#### Appendix 1 - Heritage Impact Drawings

PRIORY FARMHOUSE FREEFOLK PRIORS FREEFOLK OVERTON HANTS

#### Appendix 2 - Commentary on Pre-Application Advice

#### Email Daniel Ayre Senior Conservation Officer 10th September 2021

**Existing Attic Floor**

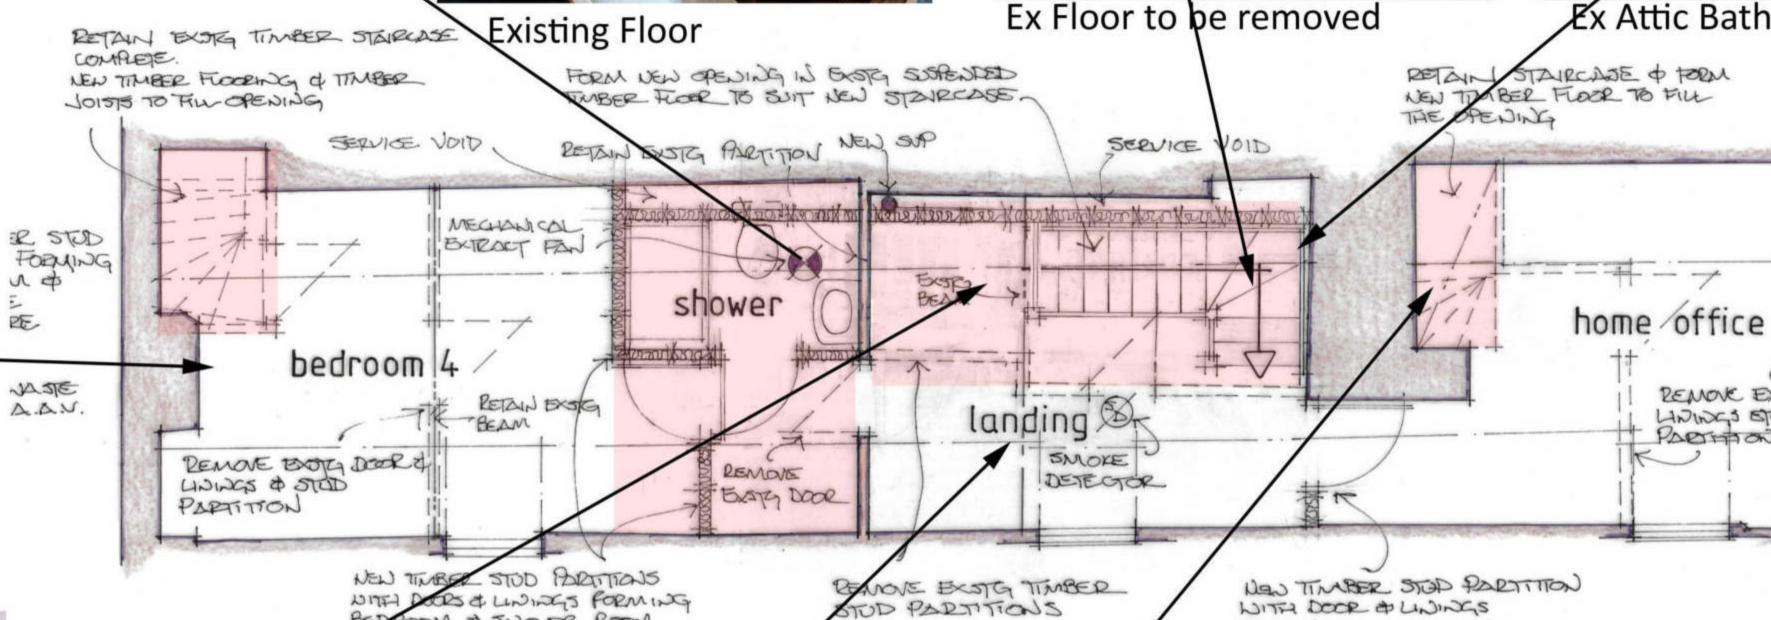
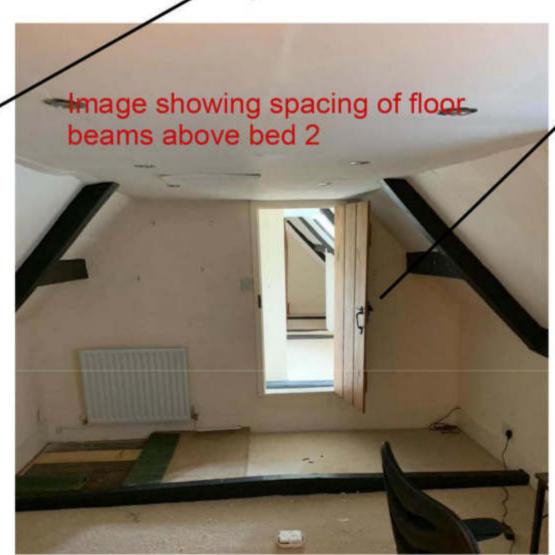
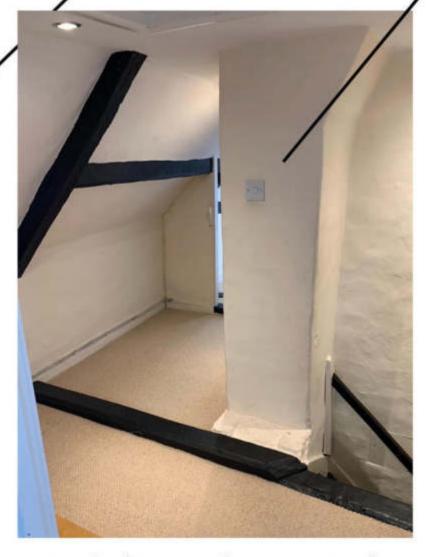
Installing a new stair could be justified if the amount of historic fabric to be altered is minimised (principally historic floor/ceiling structure). Unclear what historic fabric remains in Bedroom 2/attic bathroom.

The ceiling/floor above bedroom 2 would appear to be contemporary with the construction of the house – being constructed of plaster and lathe ceiling below ceiling joists morticed between floor joists at approx. 2.5m centres. The joists are covered by the ceiling and stand proud of the boarded floor. The images appended show the construction of the floor in the area suggested for the new loft access.

The dividing wall (with raised doorway) is a plaster/lathe + studwork frame construction with more recent raised doorway.

The reason for the raised threshold is unclear as whilst there is surface mounted pipework, there is no structural beam below the line of the wall.

As originally drawn, the stair flight would require part of the studwork dividing wall to be removed – but has now shown re-designed to avoid this.

Note: As drawn the stair location is 'flipped' to avoid the primary tie beam - loss of ex floor fabric being unchanged

Proposed 1st Floor Plan Extract

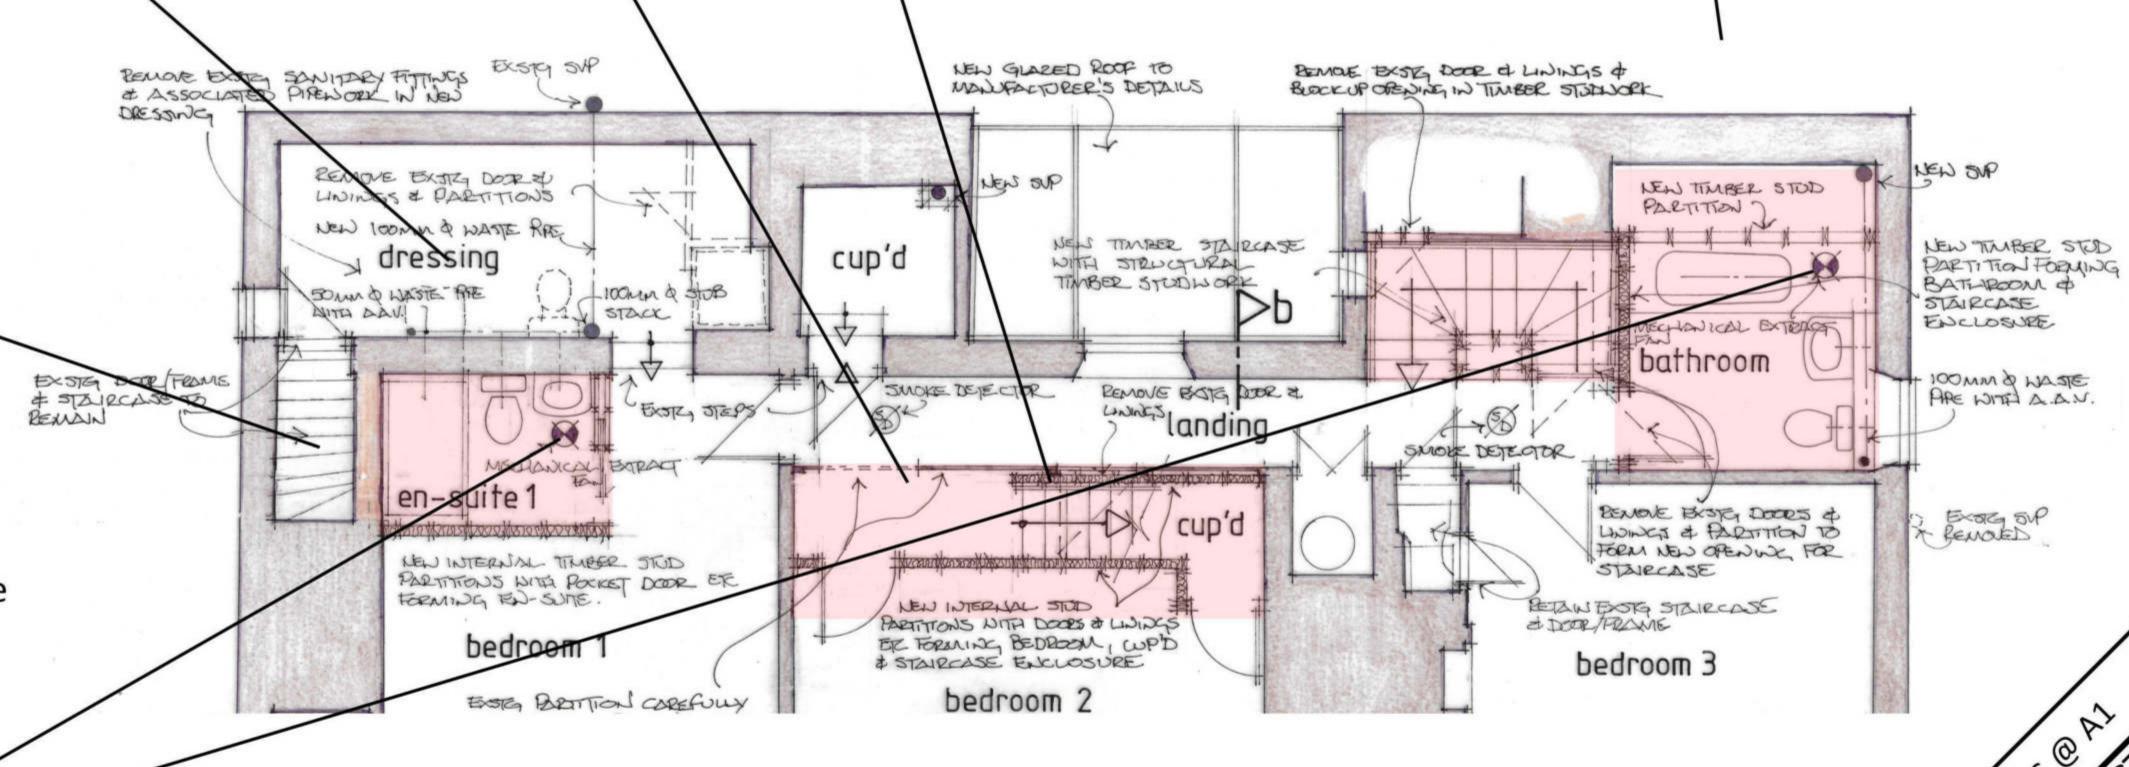
I think that the works to the ground floor utility area and corridor are unlikely to have adverse impacts on the significance of the building. I would recommend some form of mechanical ventilation for the new bathroom (and any other bathroom in the building). Care will need to be taken in how the external vent terminals are detailed. The new en-suite to bedroom 1 may prove tricky to address, due to the lack of an external wall.

Relocated SVP and Bathroom extract via discrete plain tile vents in roof

**Existing Stairflight**

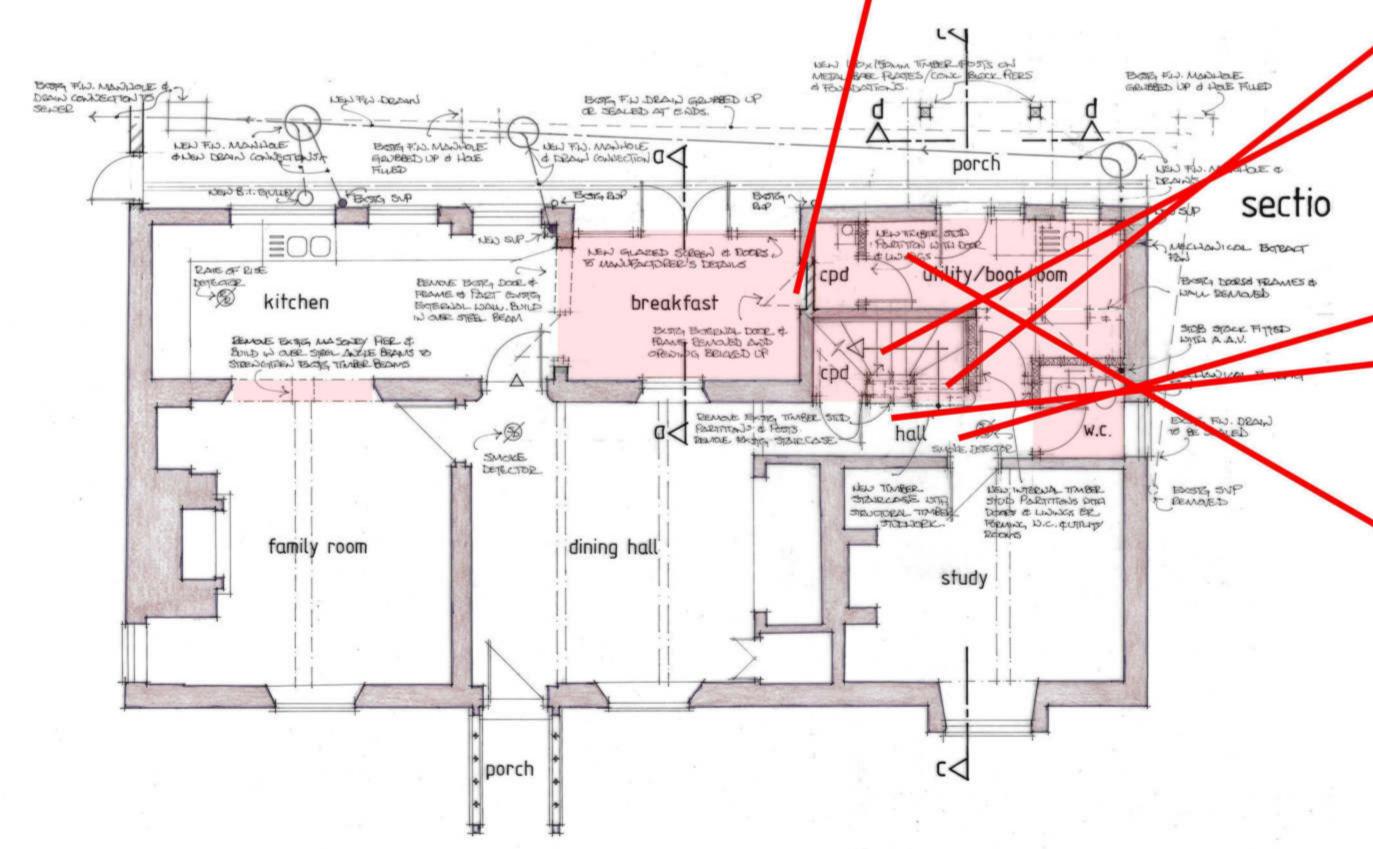
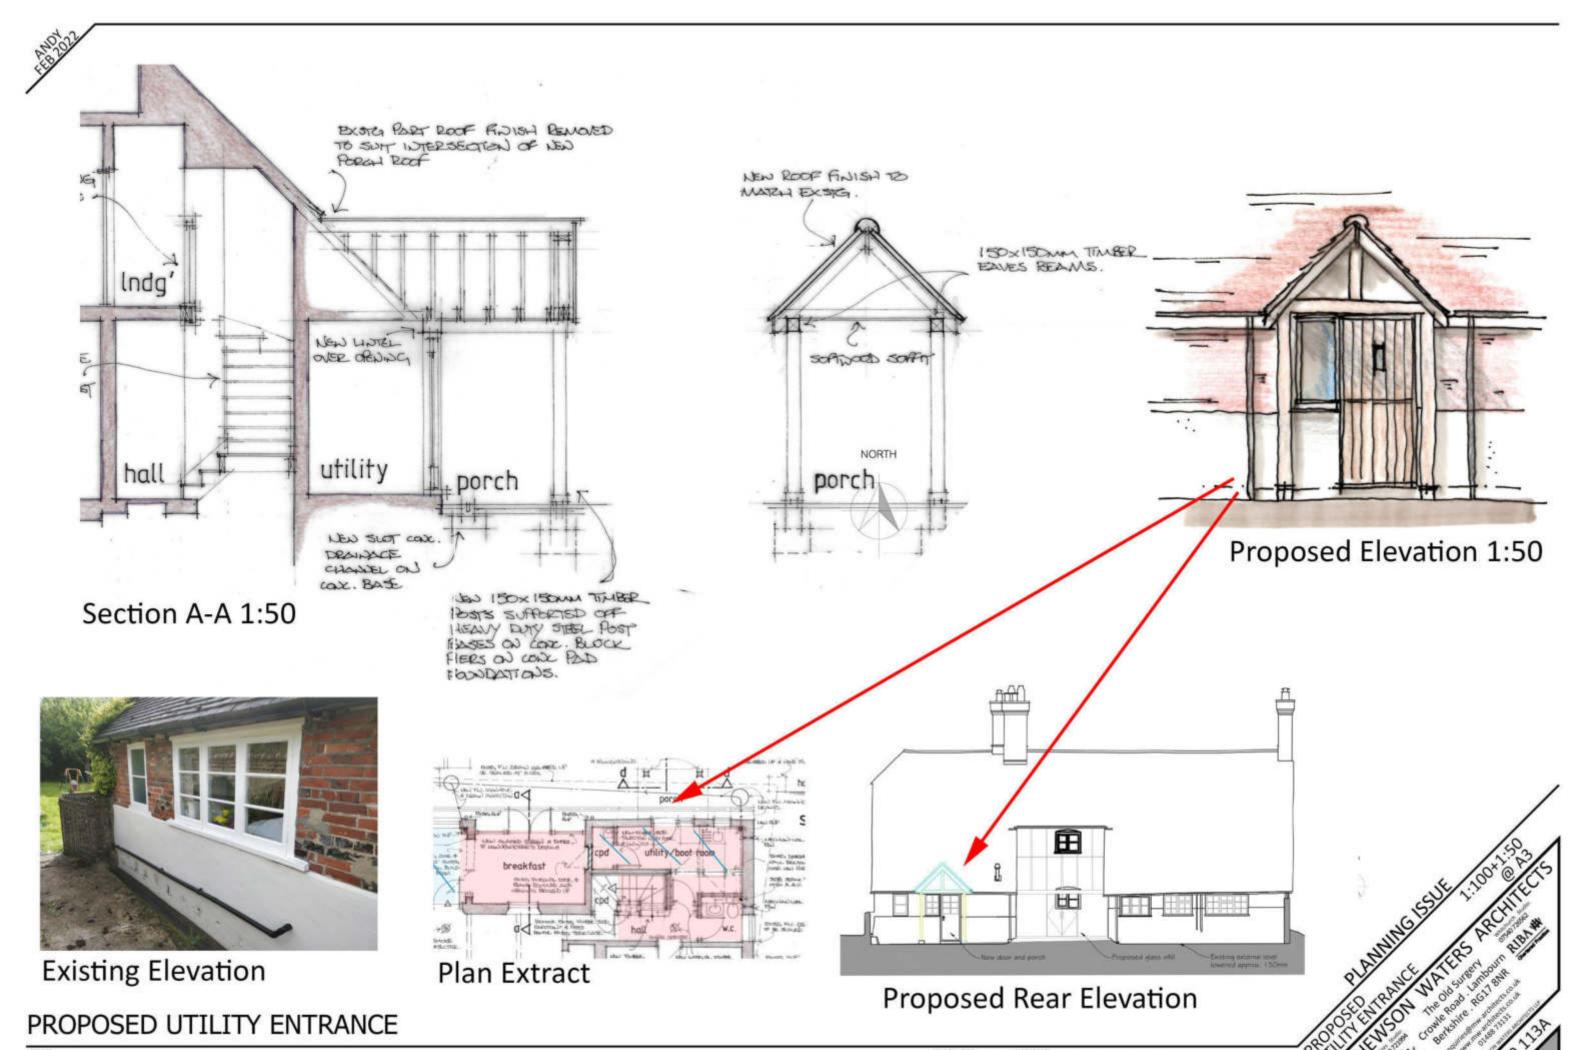
The sketch plan shows the lower flight re-instated with winders - images of existing appended The current stair is of differing width with the lower flight wider having been replaced more recently.
